**ADDENDUM NO. 5
NEW CREAMERY ROAD SEWAGE PUMP STATION
CONTRACT NO. 001**

TOWN OF EMMITSBURG, MARYLAND
 NEW CREAMERY ROAD SEWAGE PUMP STATION
 EMMITSBURG, MARYLAND

DRAWING NUMBER
C2

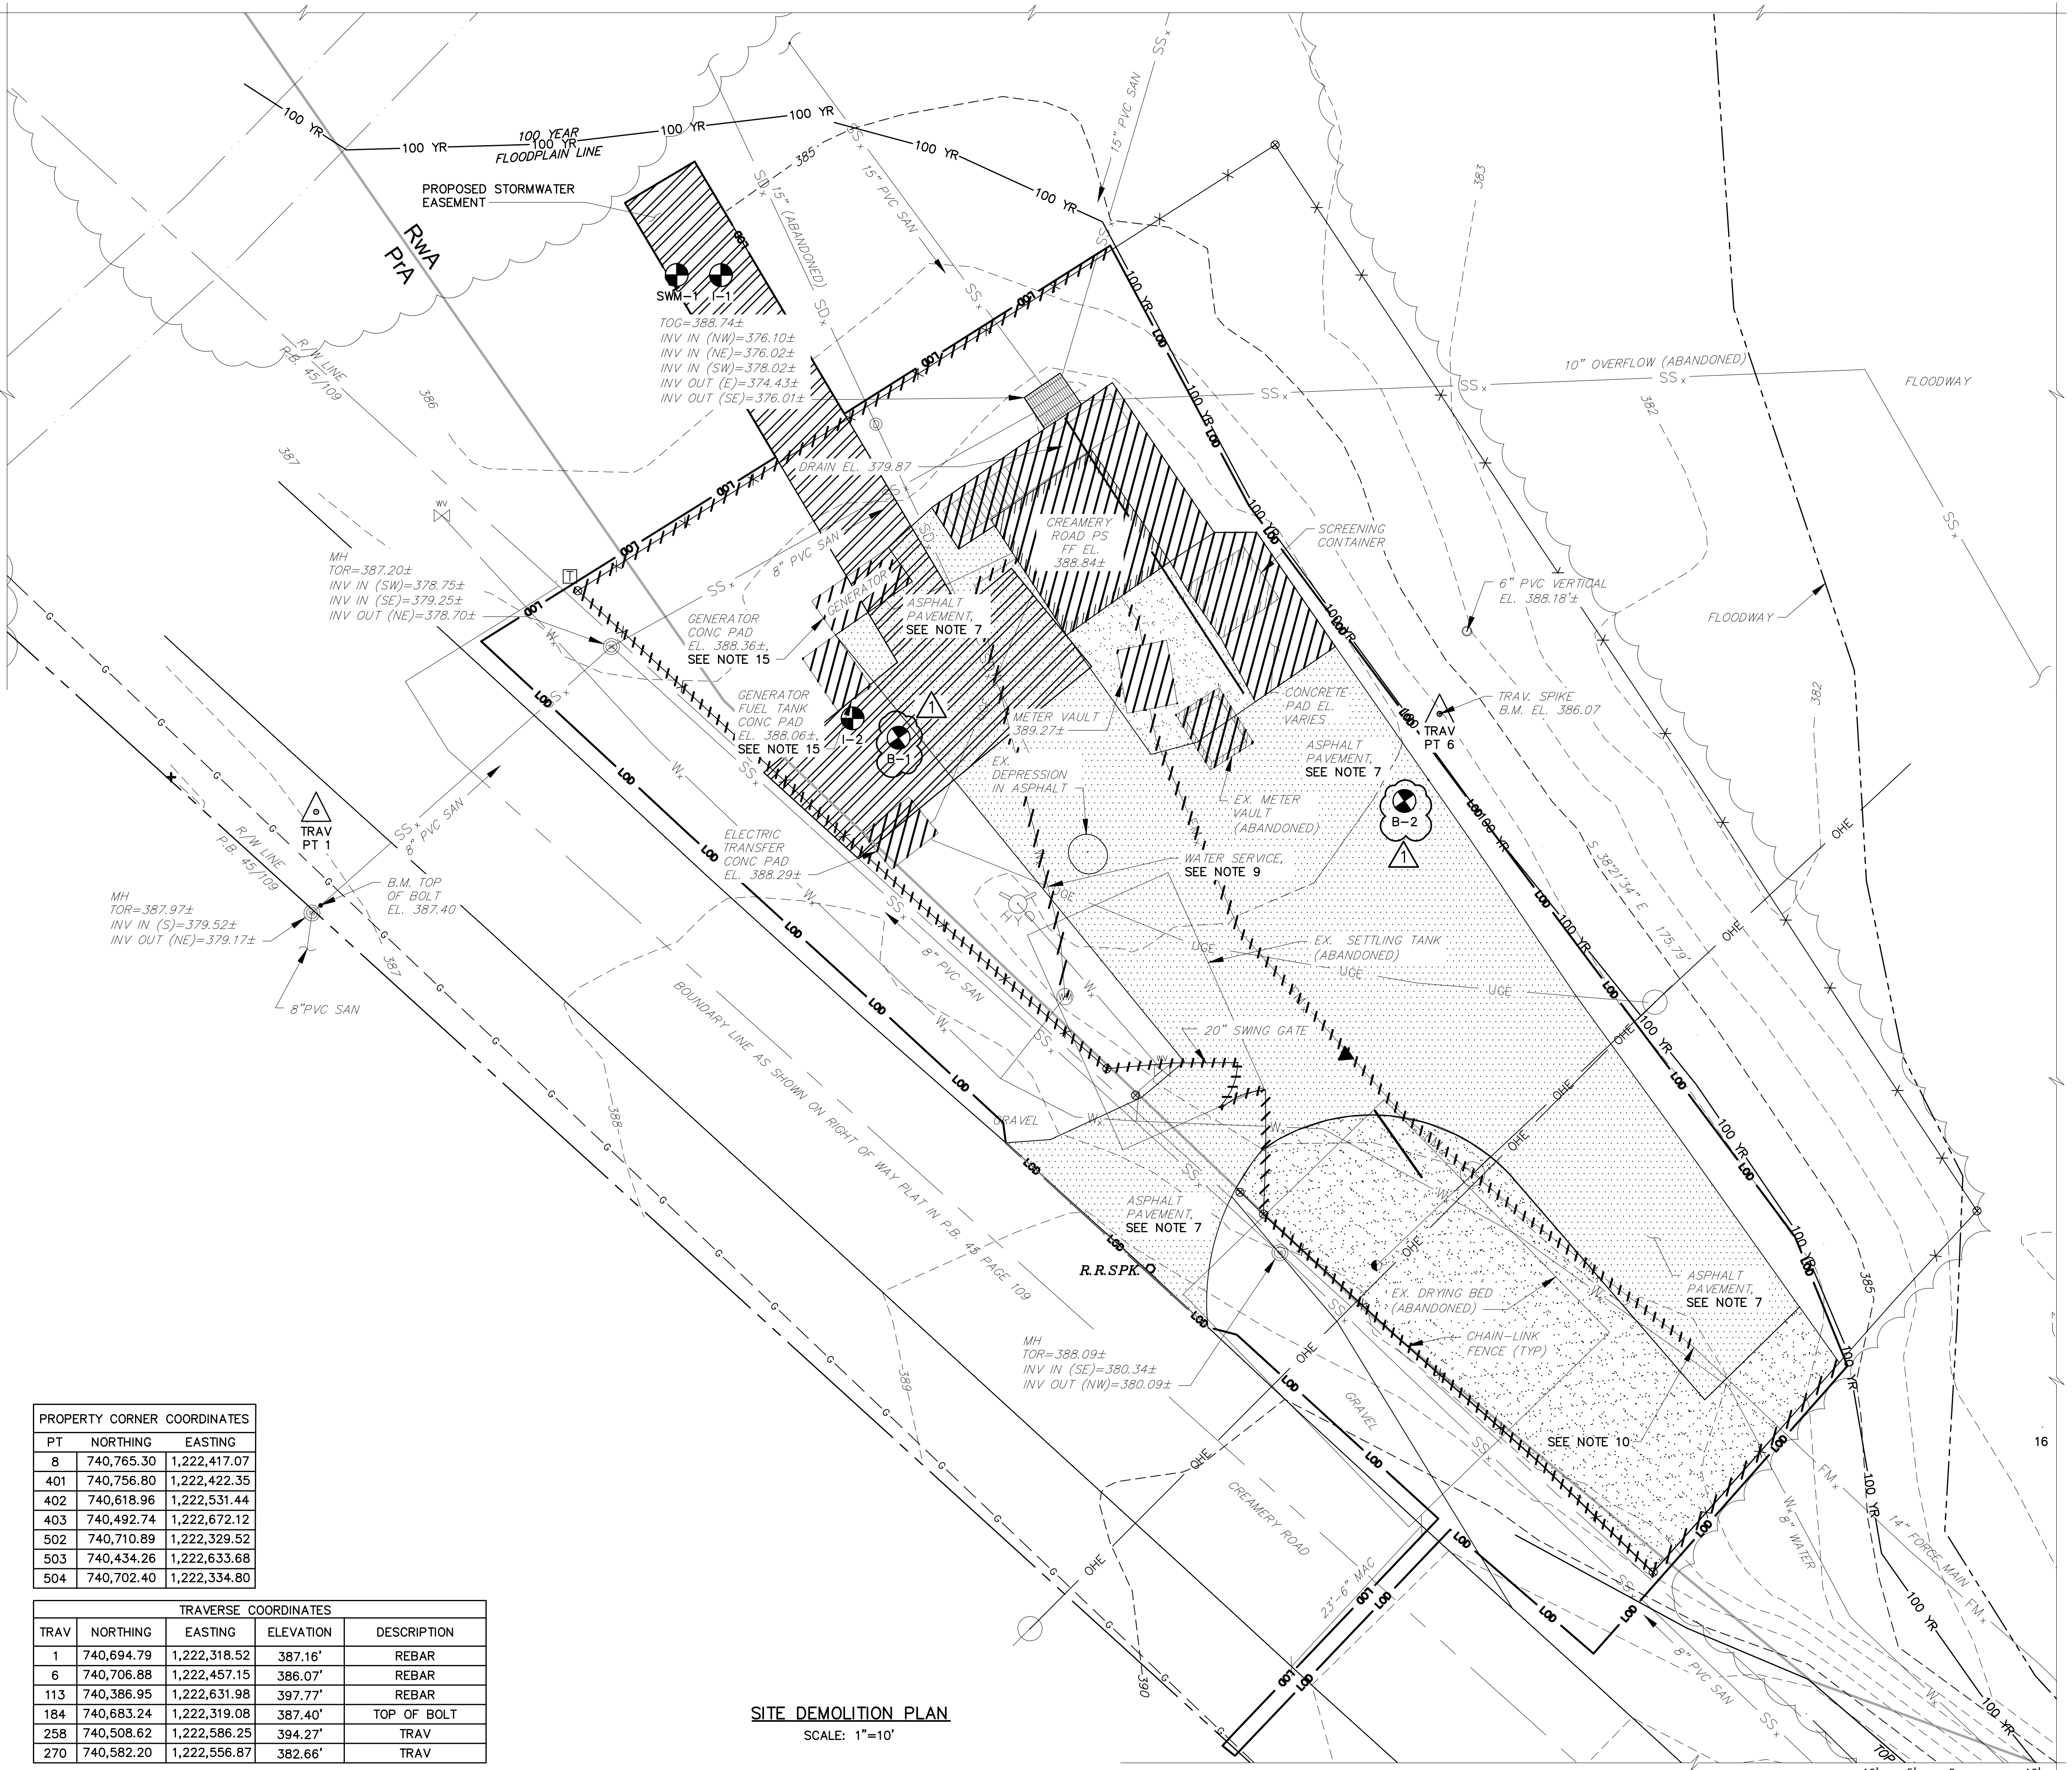
2. *Plan Sheet C2 shows the locations of Test Bores 505, 508, I1, I2, SWM 1. However, in the project manual we can only find Boring Logs for Borings B1 & B2. Please clarify the location on site of Borings B1 & B2, and also provide bore logs and soils information for all test pits/borings shown on plan sheet C2.*

10. *Does anything need done with the existing Settling Tank shown on plan sheet C2?*

11. *Does anything need done with the existing Drying Bed shown on plan sheet C2?*

All test bores labeled 505 and 508 shall refer to Borings B-1 and B-2, respectively. See attached revised Sheet C2 and SWM-1. Bore logs/soils information for SWM-1 is attached. Infiltration rates for Borings I-1 and I-2 are also attached.

The Contractor shall consider the information provided on Sheet C2 regarding the existing settling tank and impacts on construction and include all associated costs within the bid to complete construction. Note that the settling tank has not been used as a settling tank since the pump station was built between 1986 and 1990.

The Contractor shall consider the information provided on Sheet C2 regarding the existing drying bed and impacts on construction and include all associated costs within the bid to complete construction. Note that the drying bed has not been used as a drying bed since the pump station was built between 1986 and 1990.

**CONCRETE FLAT-PAD FOUNDATION
PAD-MOUNTED TRANSFORMER 75 TO 500 KVA,
THREE-PHASE, 34.5 KV & BELOW HIGH-SIDE**

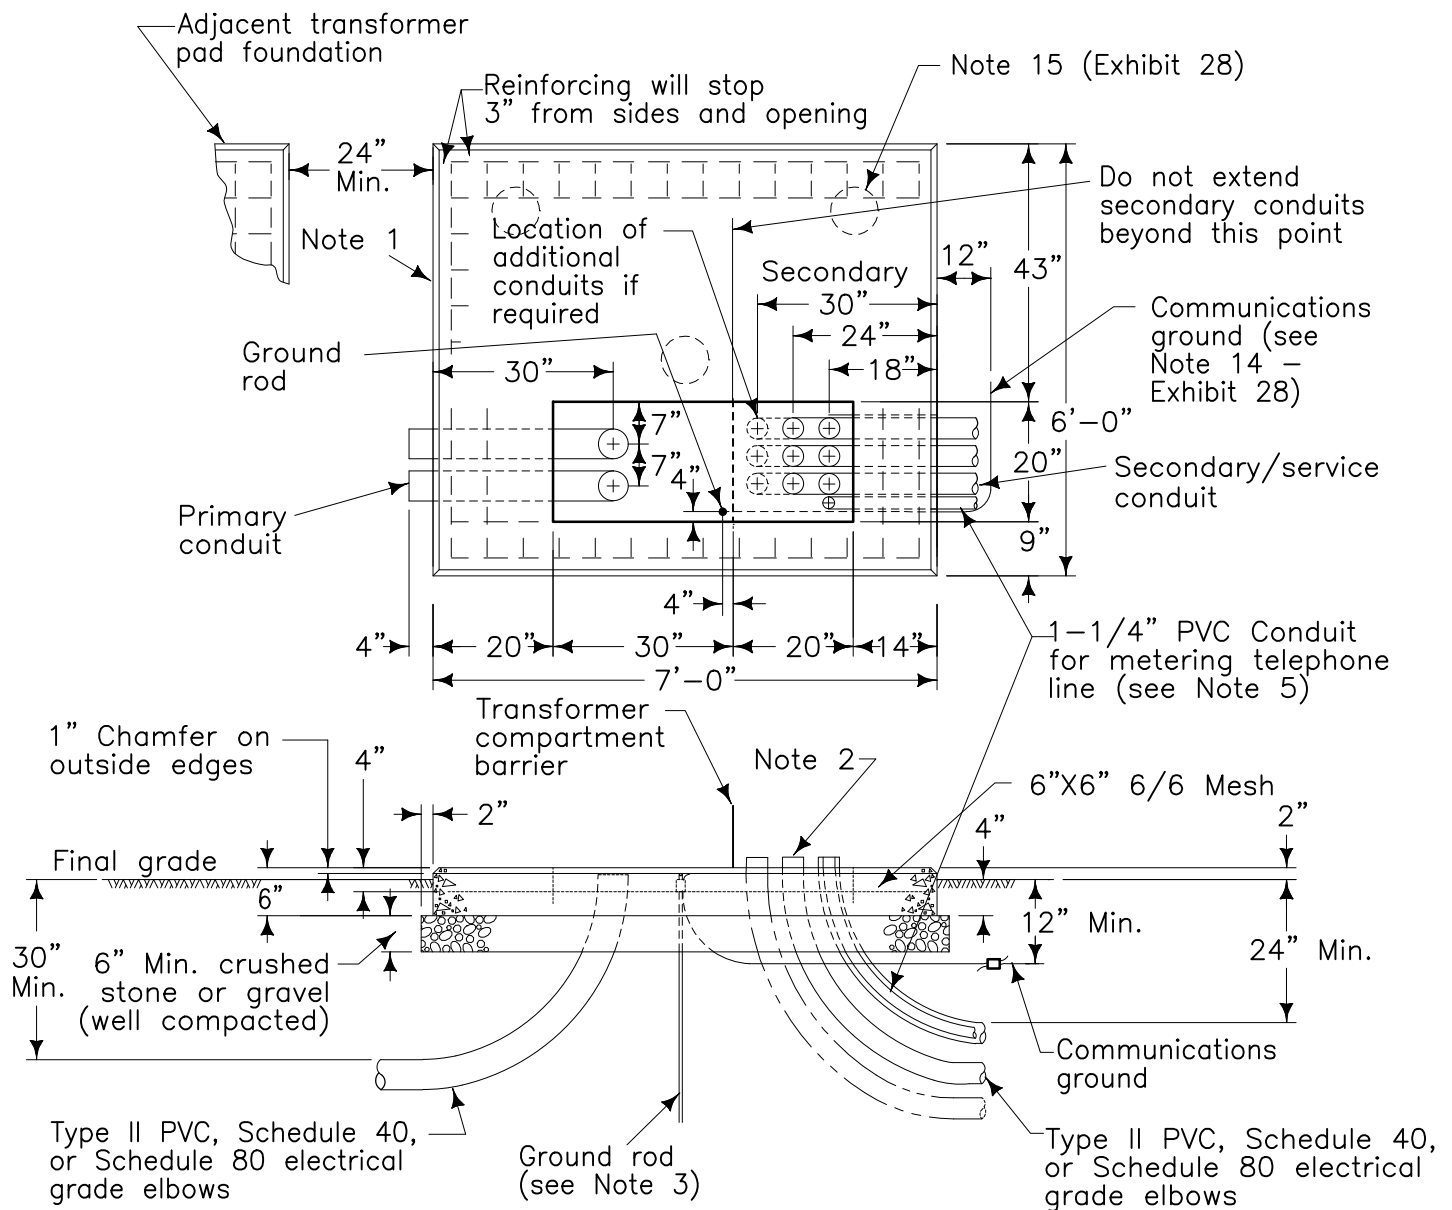
22. *Plan Sheet E2. Please provide the detail for the power company transformer pad referenced on Sheet E2, Note 2.*

See attached standard detail for the power company transformer pad. The transformer pad shall be constructed in accordance with Potomac Edison requirements. Contractor shall coordinate with Potomac Edison for the transformer pad.

UTILITY TRENCH BACKFILL/PAVEMENT REPAIR DETAIL #1

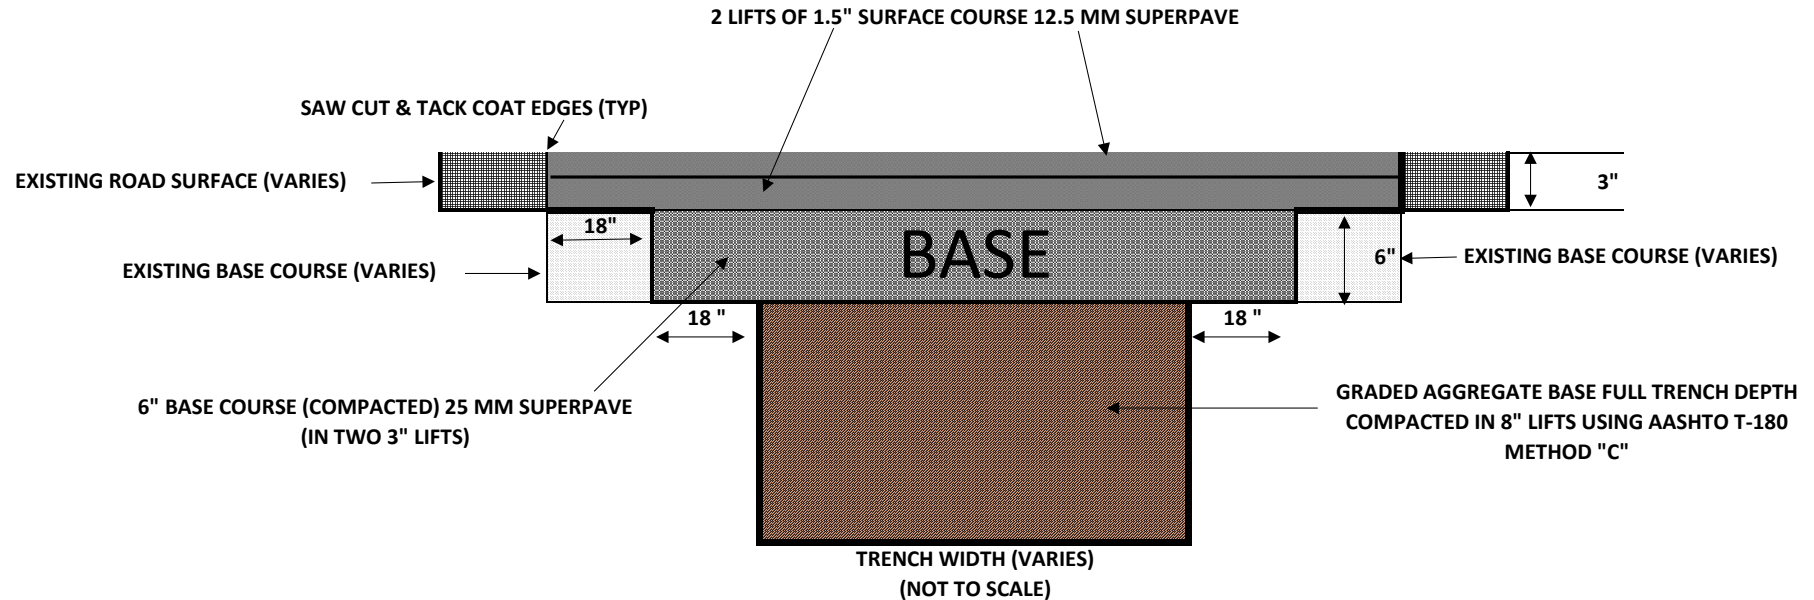
24. *Plan Sheet C3 Please provide a paving restoration detail for the gas line utility patch on Creamery Road.*

Contractor shall refer to the Frederick County Utility Trench Backfill/Pavement Repair Detail #1 for Bituminous Concrete Roadways for the pavement restoration on Creamery Road. Detail attached.
